PRELIMINARY/FINAL DRAINAGE REPORT

**MIDTOWN COLLECTION AT HANNAH RIDGE
FILINGS 1 AND 2**

PUDSP-19-004

March 2019

DESIGNED BY	KRC	SCALE	DATE
DRAWN BY	LDB	(H) 1" = 30'	03/22/19
CHECKED BY	(V) 1" = NA	SHEET 3 OF 3	JOB NO. 1116.30

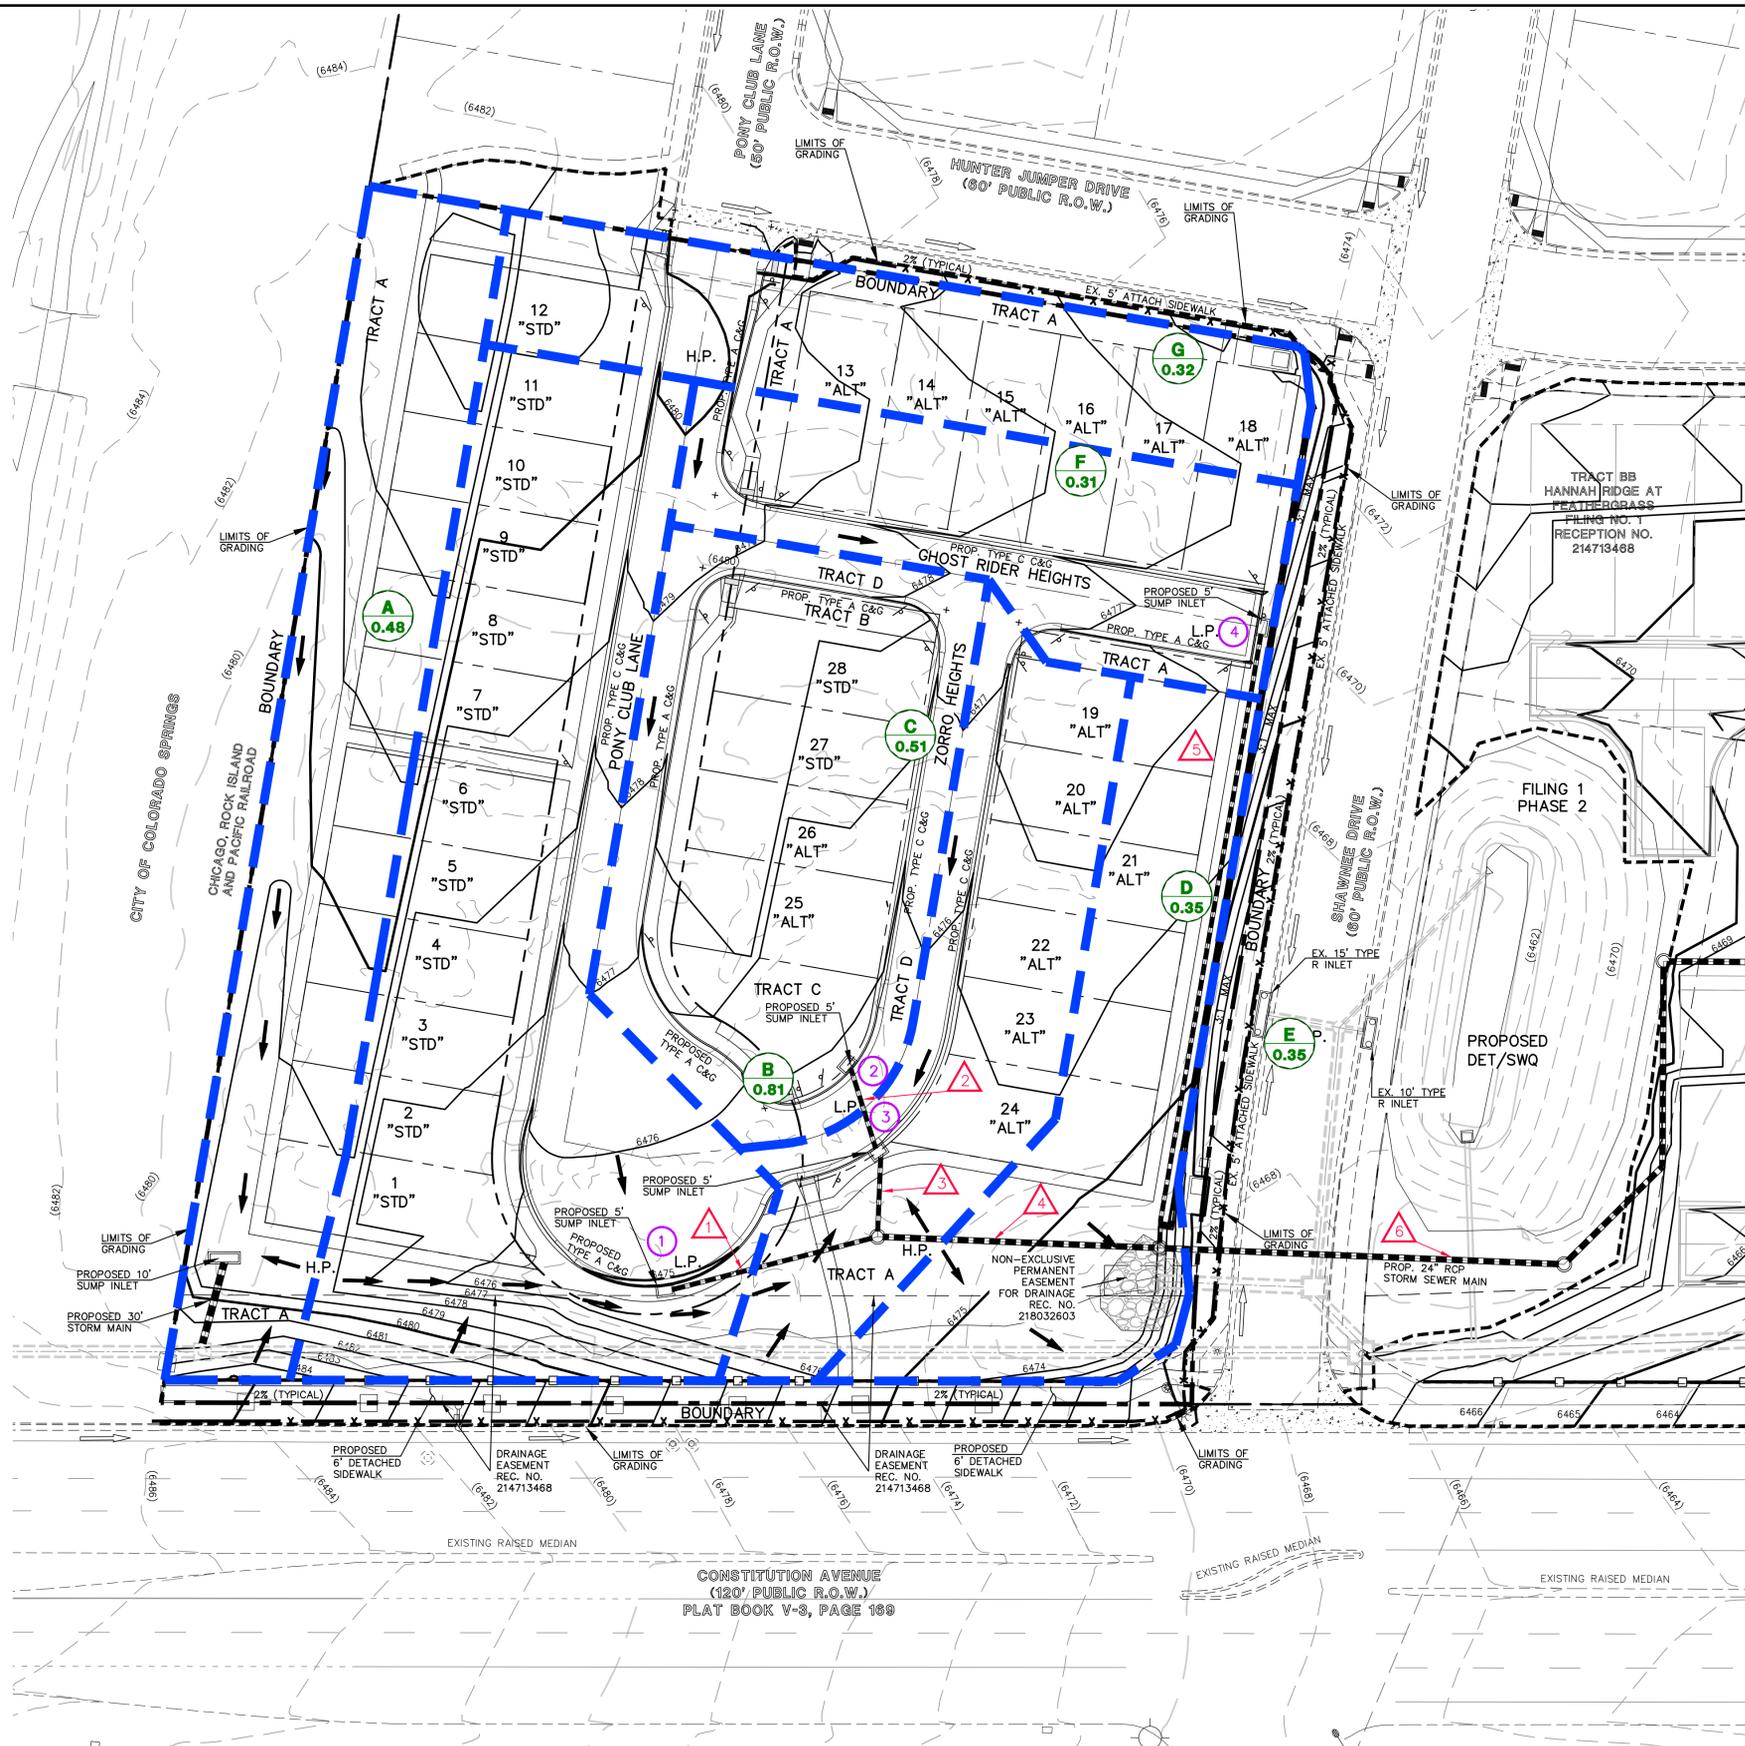
Include acres of basins in this table as well as which pond it is routed to.

In the first review we indicated that basin E (now basin D) needed to be routed to SWQ/FSD treatment. And it appeared that basin A was being routed to treatment, however, now the drainage plan shows it is being captured and not being treated. Please route these basins to treatment facilities and discuss in the developed drainage conditions that all of the development area (excepting up to one acre per filing 2 and .65 ac. per filing 2, 20%) is being treated. As it is currently proposed the it does not appear that this requirement is being met.
